Groundwater Application Review Summary Form

Application # G- 18717

SUBJECT: Application G- 18717

A. GENERAL INFORMATION: Applicant's Name: Richard W. Todd County: Clackamas

Well Location Map

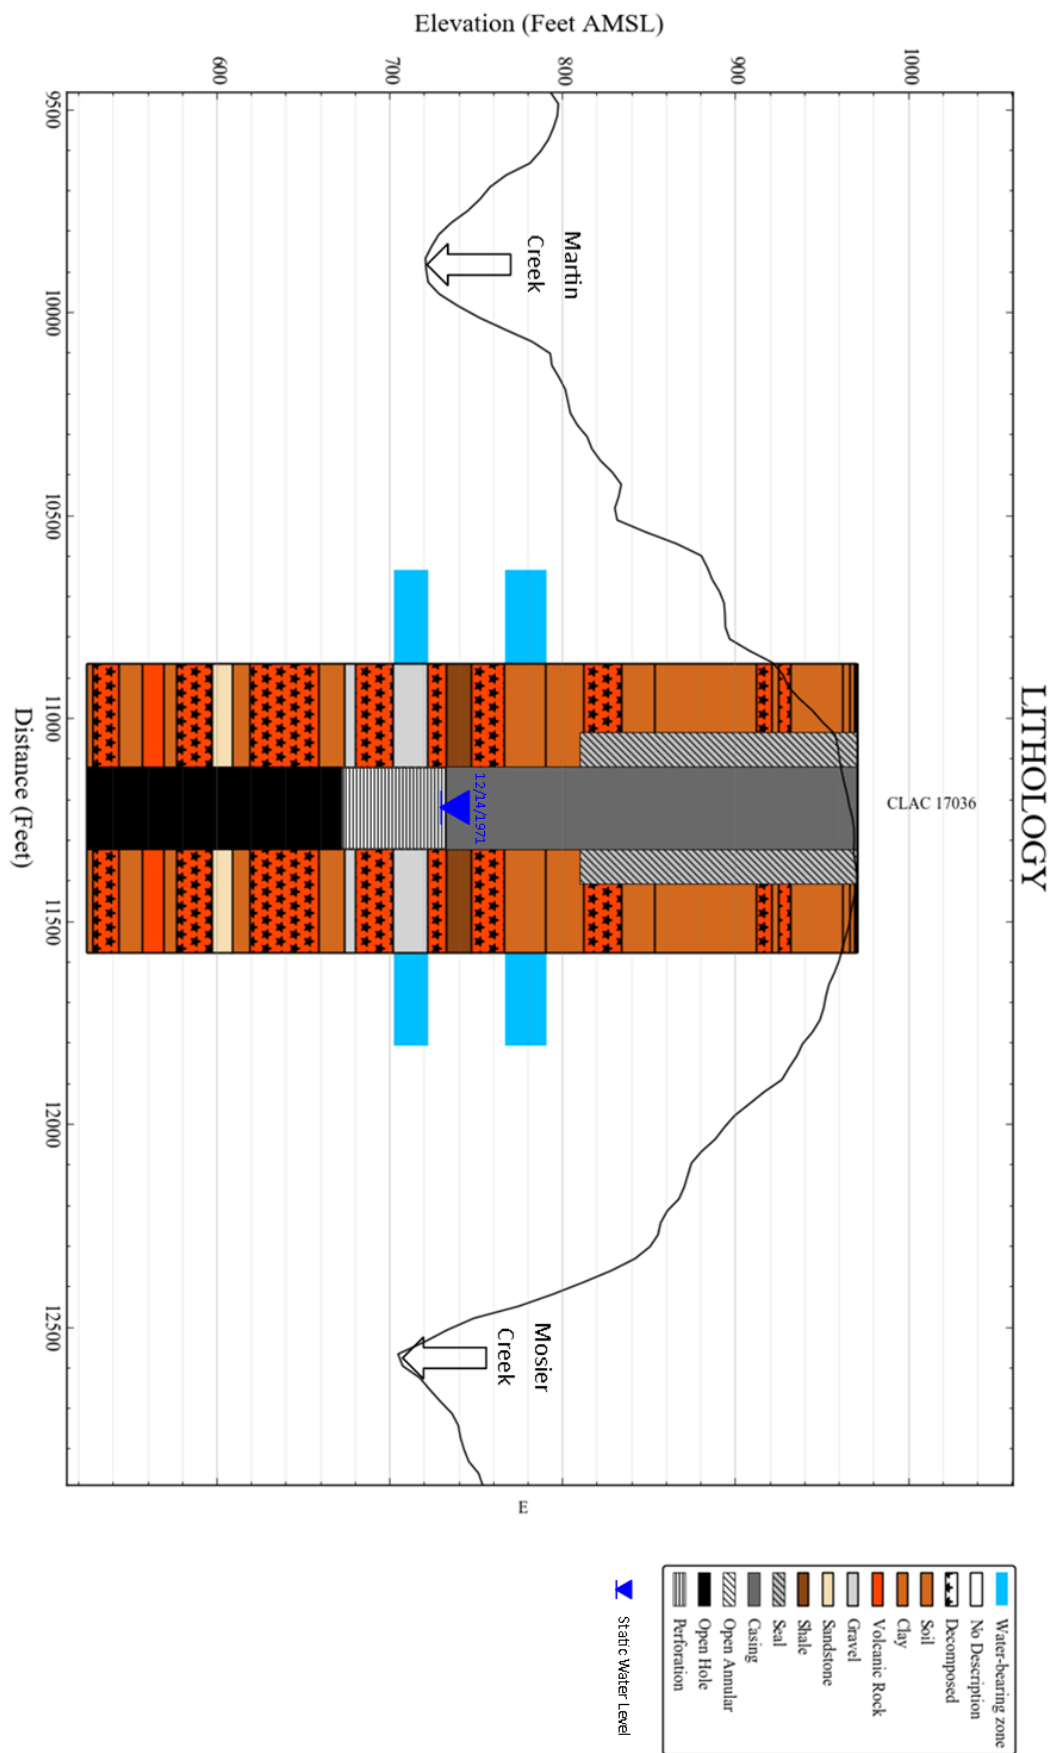
A4. **Comments:** The requested POA/POU is located approximately 3.75 miles southeast of the unincorporated community of Beaver Creek, Oregon.

^b The requested POA Logid is identified as "MULT 17036" in both the provided Water Rights Application Map and Section 3 of the Application for a Permit to Use Groundwater. However, the location indicated on the Water Rights Application Map corresponds to the location identified for CLAC 17036. In the well specific table for Section 3, the POA Logid is referred to as "CLAC 17036". Therefore, it has been assumed that CLAC 17036 is the correct Logid for the requested POA.

WELL CONSTRUCTION & LITHOLOGY – POA 1 (CLAC 17036)

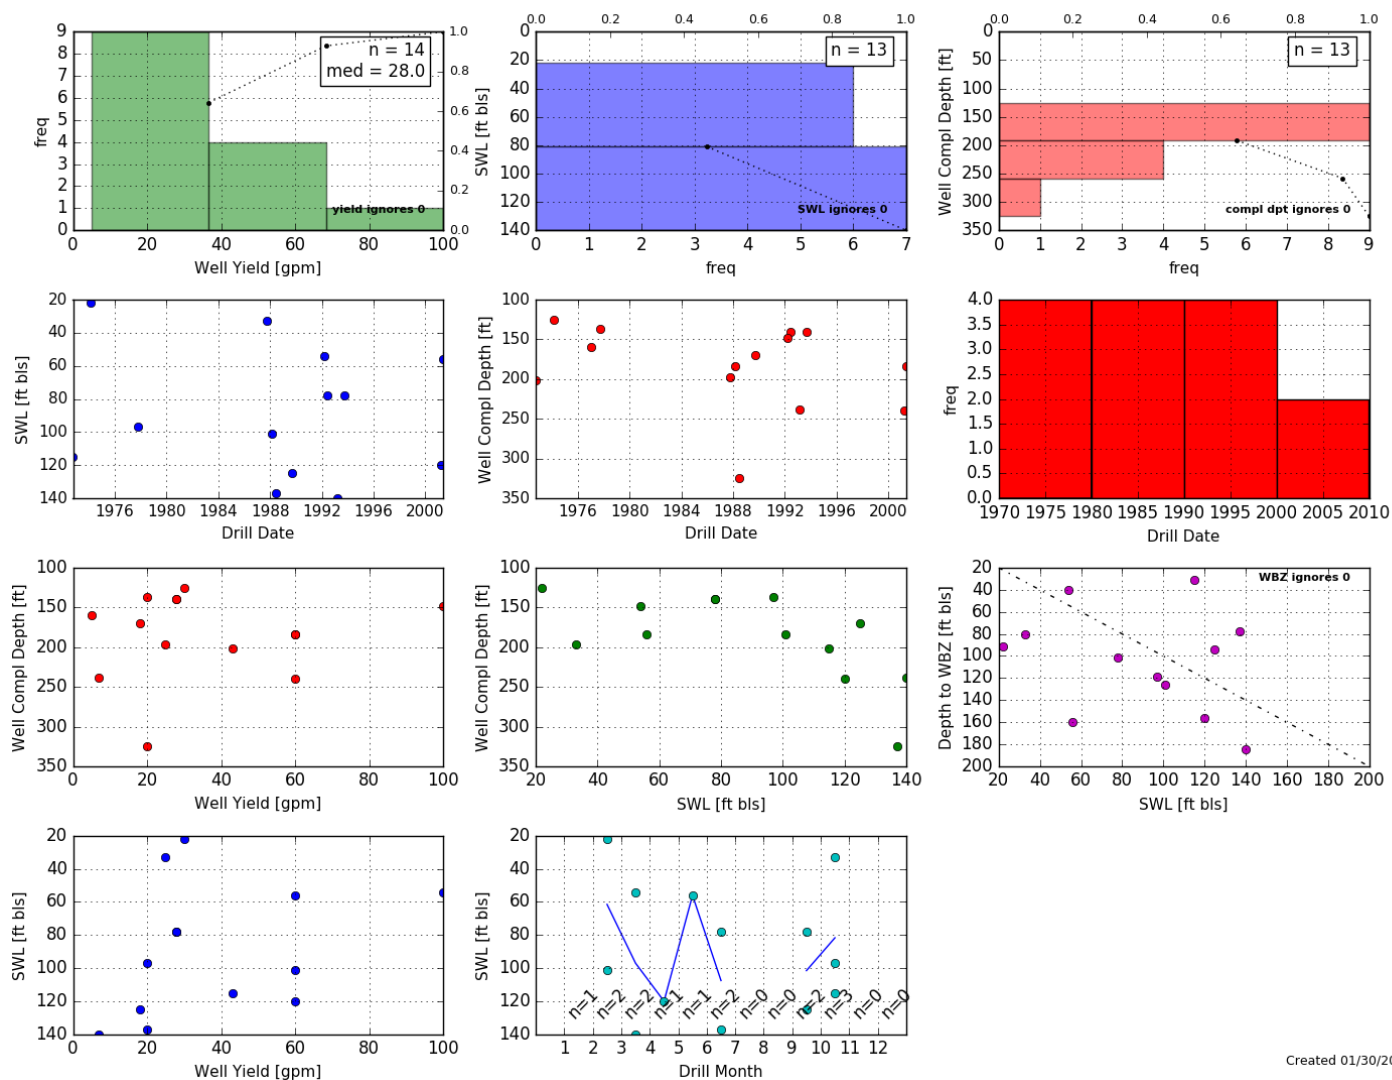
According to the Water Well Report for CLAC 17036 (the requested POA), the applicant's well appears to produce water from an approximately 20 ft thick layer of water-bearing gravel between 248 and 268 ft below land surface (bls) (elevations of approximately 718 ft to 698 ft above mean sea level [msl]), although water-bearing sandy clay was noted as extending from a depth of approximately 180 to 204 ft bls (elevations of approximately 786 ft to 762 ft above msl) (see Well Construction & Lithology, attached). This sandy clay was not sealed off and therefore may be in hydraulic communication with CLAC 17036 via the borehole annulus.

It should be noted that the requested allocation of 45 gpm (0.100 cfs) is greater than 4 times the reported yield (11 gpm [0.02 cfs]) for the POA. Either modification (deepening) of the existing well or the installation of additional wells may be necessary to supply the requested the allocation.

OWRD Well Log Query – Statistics for Reported Wells in Adjacent Quarter-Quarters

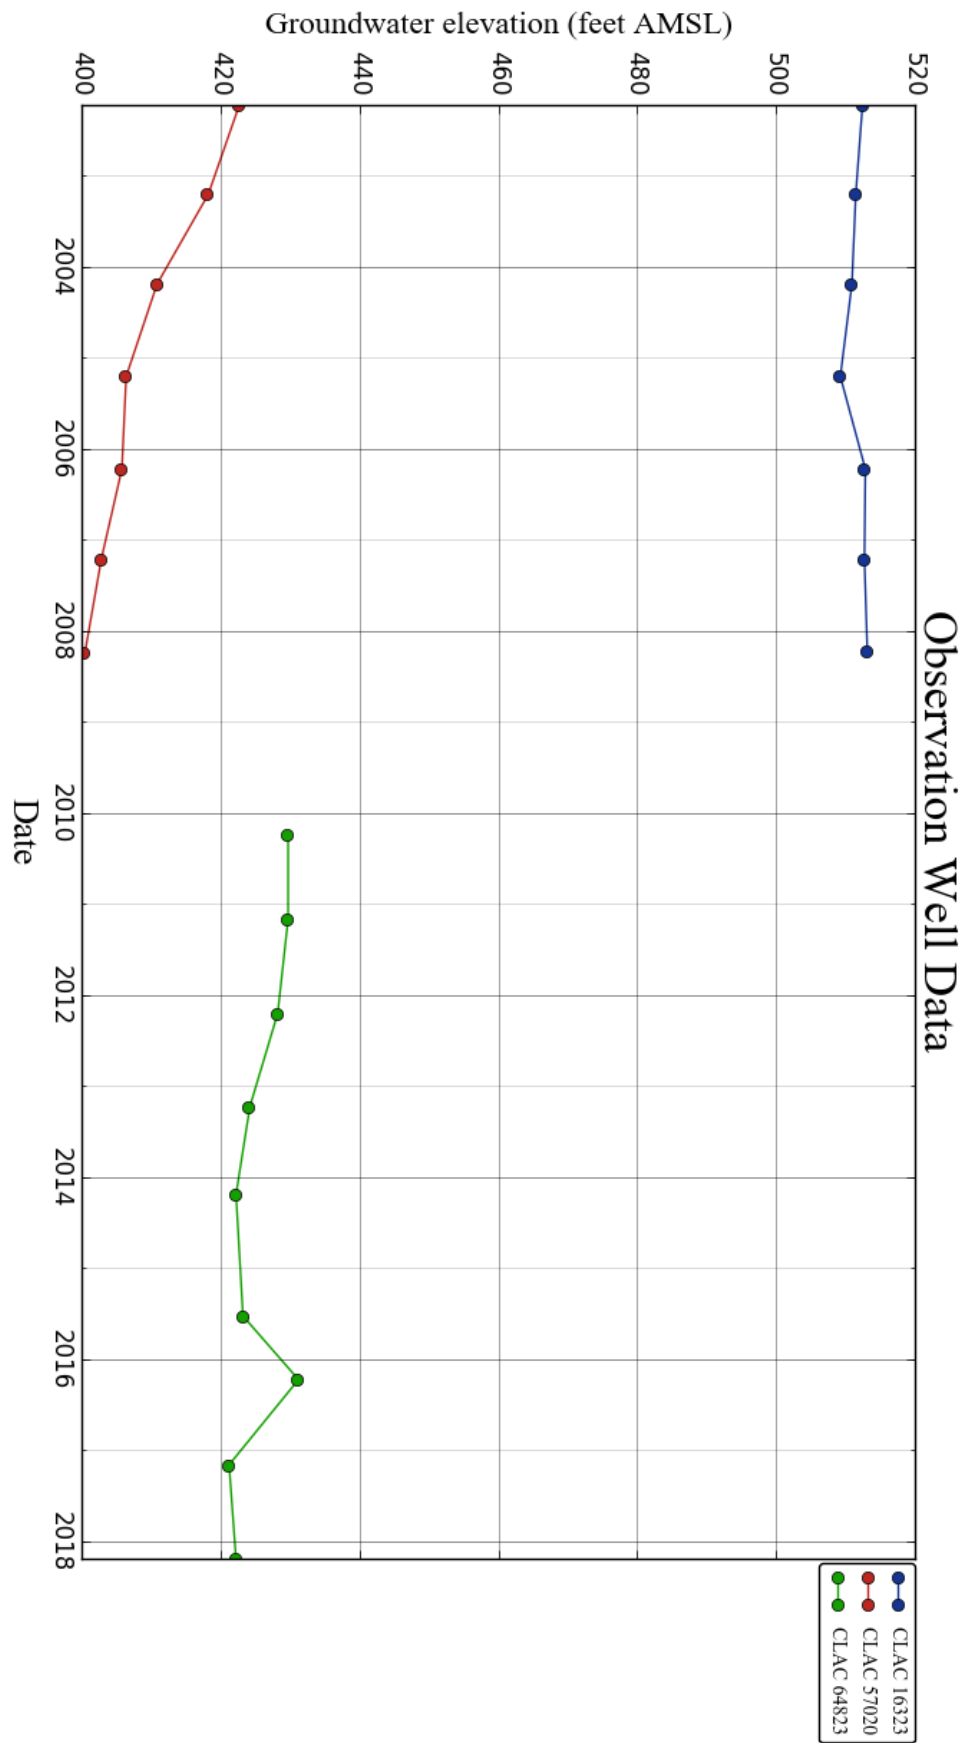
Basis for aquifer confinement evaluation: The water well report for CLAC 17036 as well as two nearby domestic wells (CLAC 17048 and CLAC 56695) indicate water-bearing zones from as shallow as 78 ft bls to as deep as 326 ft bls. Reported static water levels in the three water wells were generally above the applicable water-bearing zones, so the aquifer appears to be predominantly confined in this area.
